## TCE 22-270 RE: Allstone/Julian CU Permit Application Revisions

RE: Allstone Vermont – Julian Materials, LLC  
137 Chandler Road and 3643 VT Route 103  
Chester, VT 05143  
TCE #22-270

RE: Allstone Vermont – Julian Materials, LLC - Revised Application  
137 Chandler Road and 3643 VT Route 103  
Chester, VT 05143  
TCE #22-270

**Project:** Allstone Quarries – Chester  
**Date:** July 6, 2023, rev. December 7, 2023  
**From:** Roger Dickinson, PE  
**Subject:** Traffic Impact Assessment

Sheet Title  
**Overall North and South Site Plan**

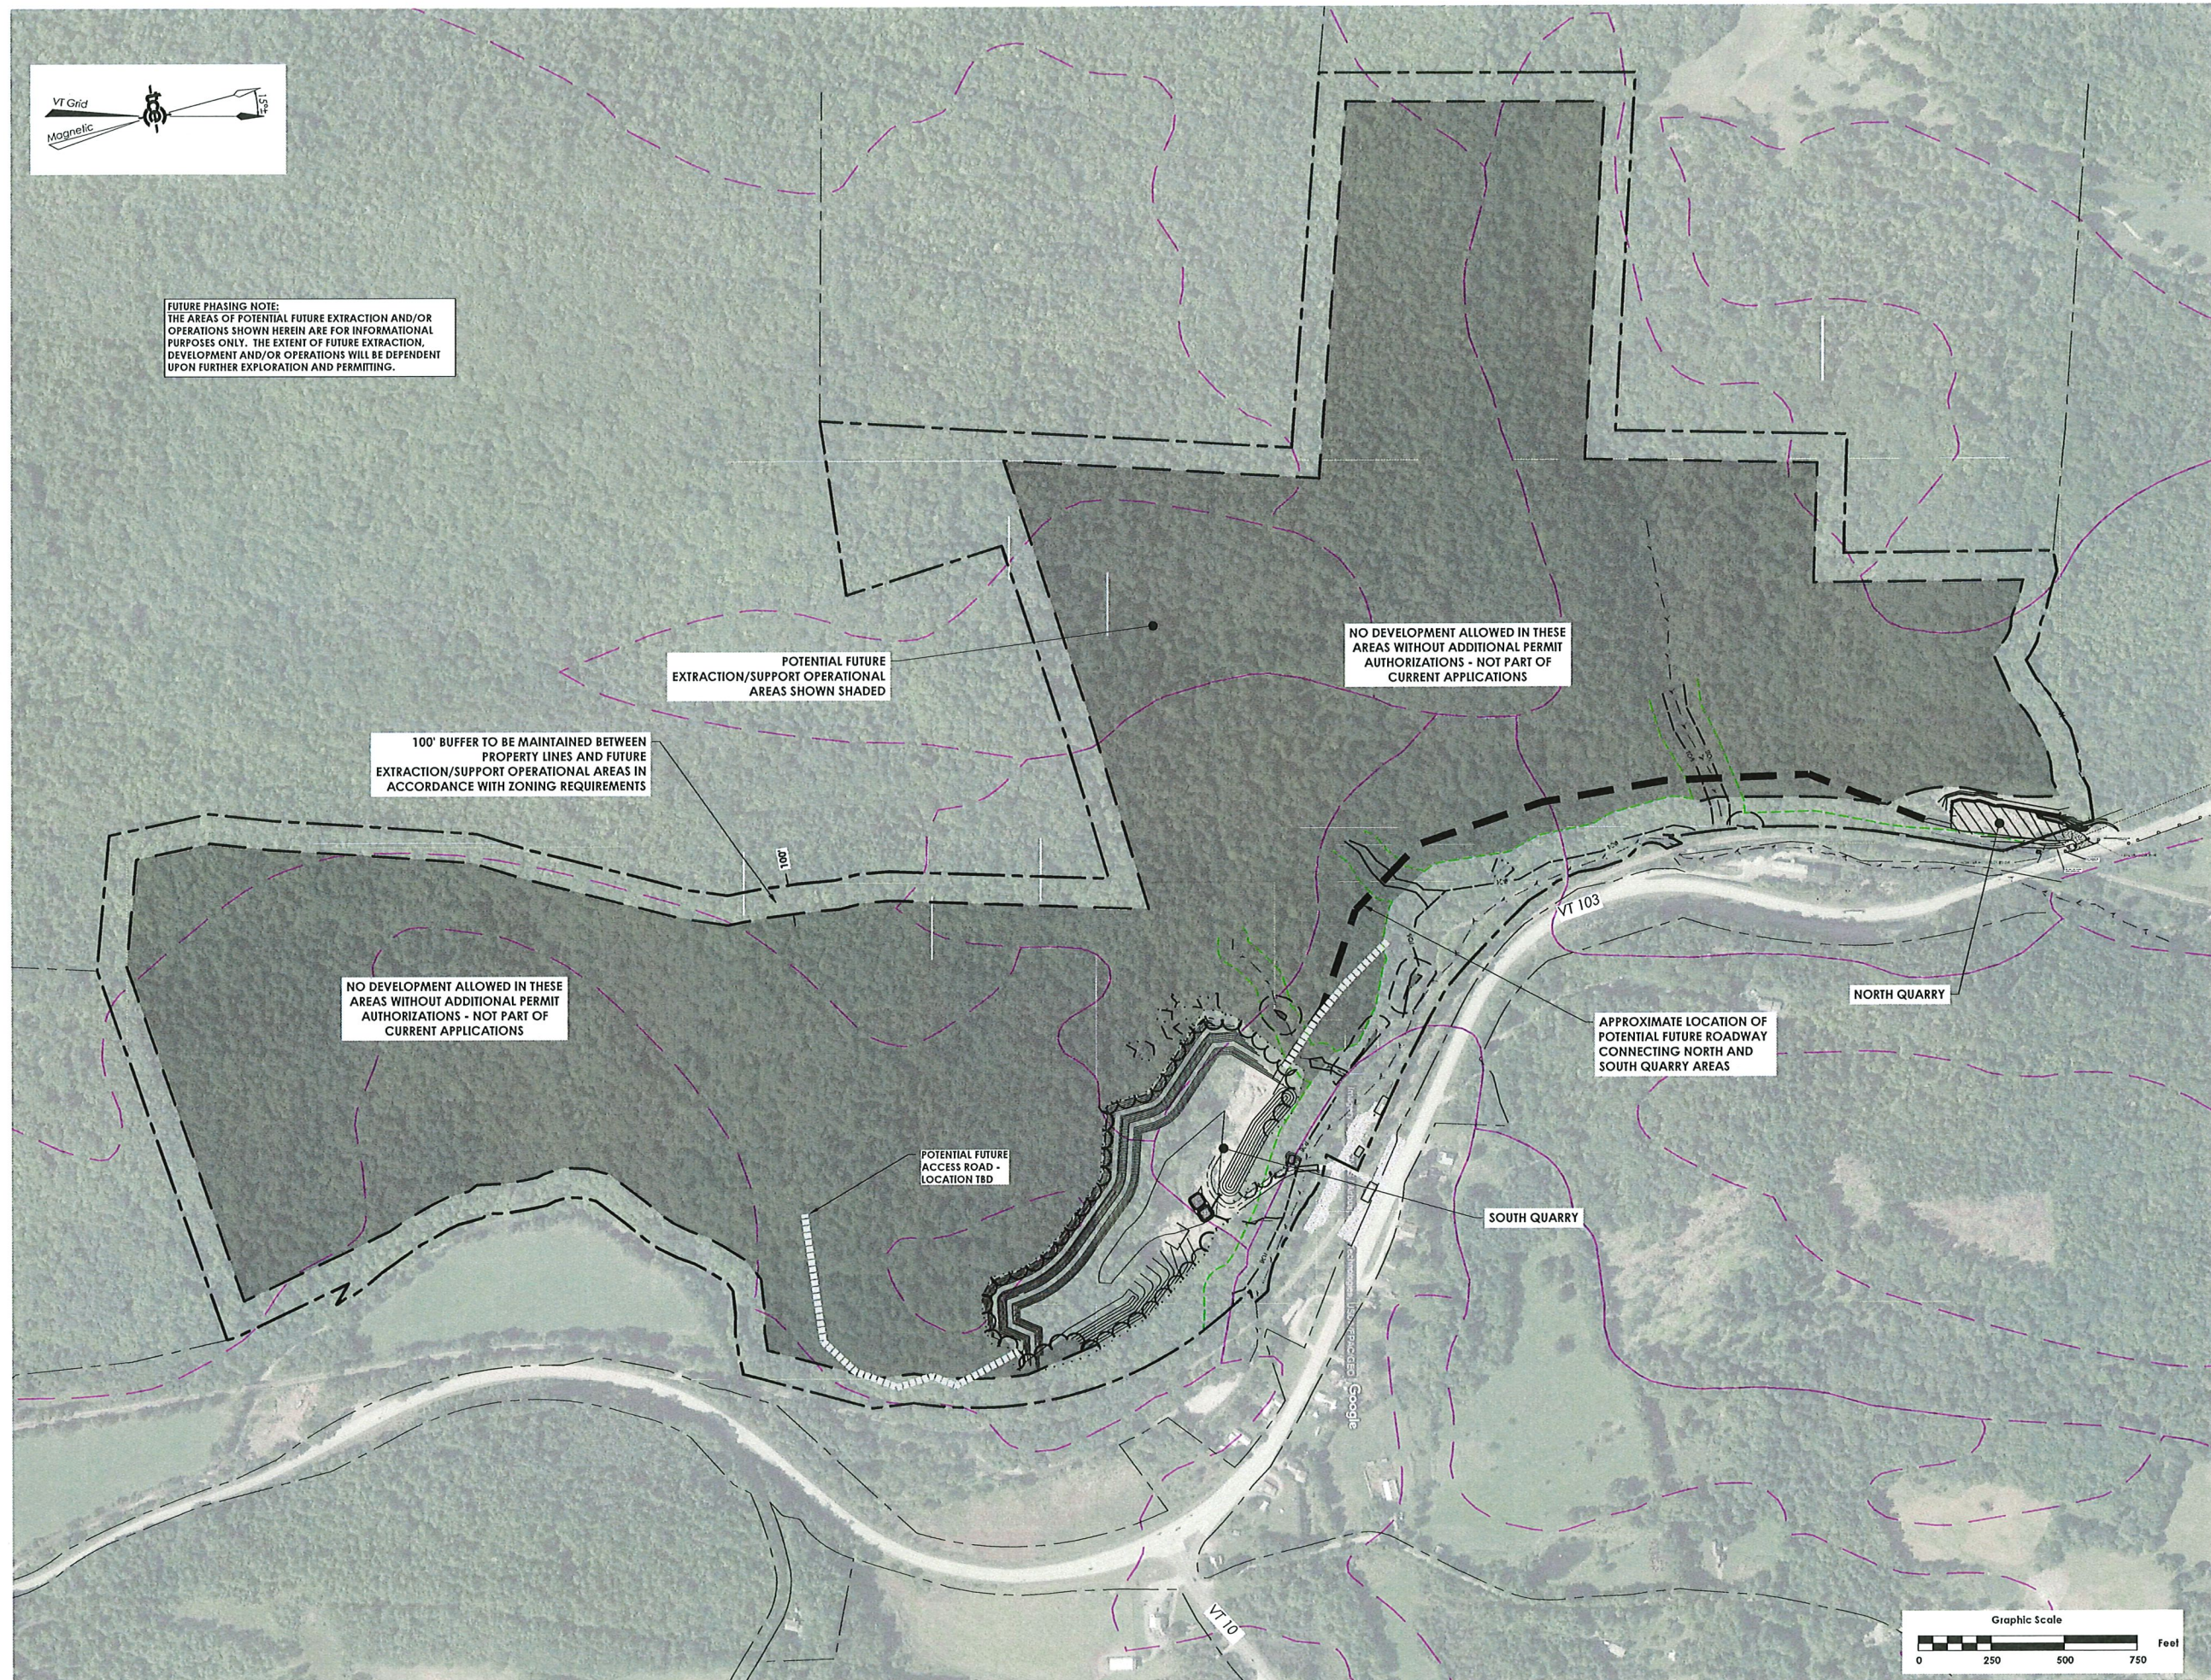
- a. Reclaim the current quarry limits and construct a contractor yard for storage and misc. support operations, e.g. storing finished product stone pallets, extra equipment, trailers, pallets, or construction vehicles when not in use. **This work will be performed no later than October 1, 2025.** Note: This site will also continue to provide access to remaining lands for forestry and future extraction operations, and a future internal haul road to connect with South Quarry. The road and any new quarries will require additional local and State permitting.

Sheet Title  
**South Quarry Site Plan**

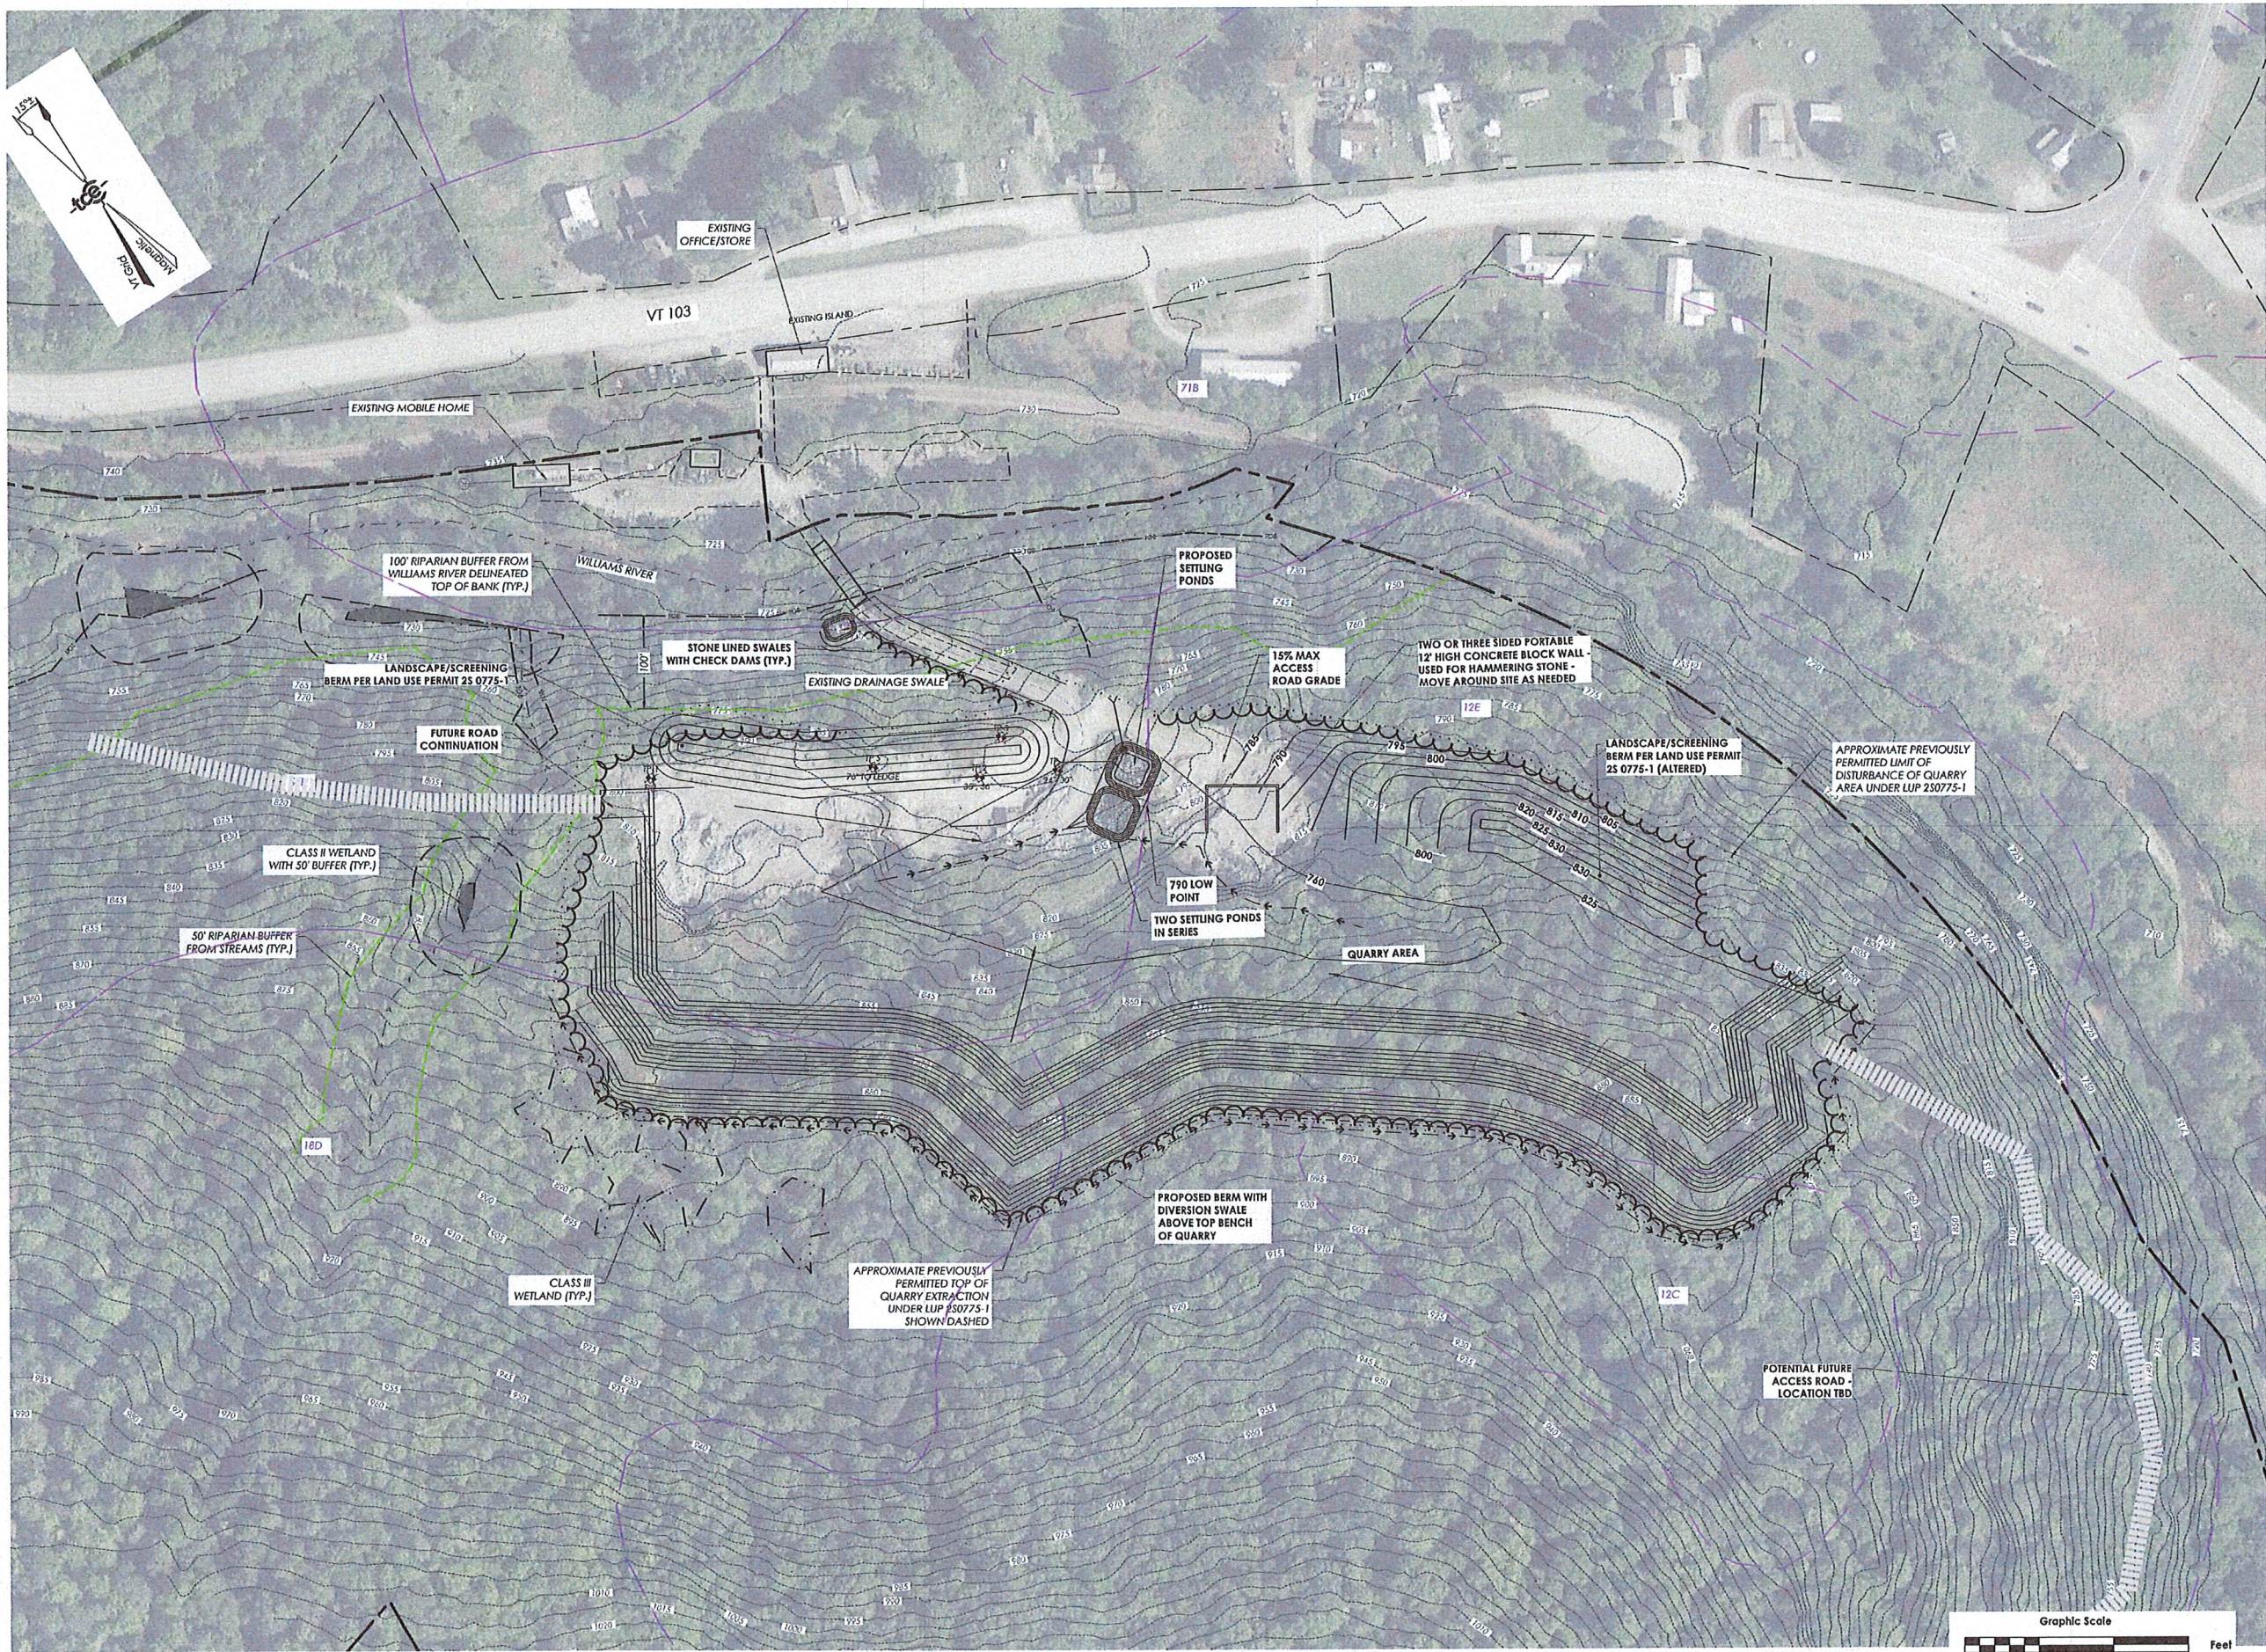
- Eliminate the proposed new metal building at the South Quarry entirely and revert to the grading limits imposed by the original permit(s), no further lowering of the quarry at this time is proposed currently, but the applicant reserves the right to submit for lowering (or expanding) the quarry in the future. Clarify that extraction limits will continue as approved by the Town and District Commission previously at this location. Blasted stone will be hauled to, and processed at, a new location outside of the town limits of Chester, VT.

- a. The South Quarry will continue to be operated in accordance with the previous approval(s) from the Town of Chester and consistent with the grading plans approved by the Town and Act 250 under Land Use Permit 2S0775-1 (altered). Use of a limited portable crusher consistent with the approved Land Use Permit 2S0775-1 (altered). Install best management practices (BMPs) including diversion berms, two centralized

stormwater settling ponds, and other practices required to ensure water quality requirements are met for discharge from the site in accordance with a Multi-Sector General Permit (application pending)
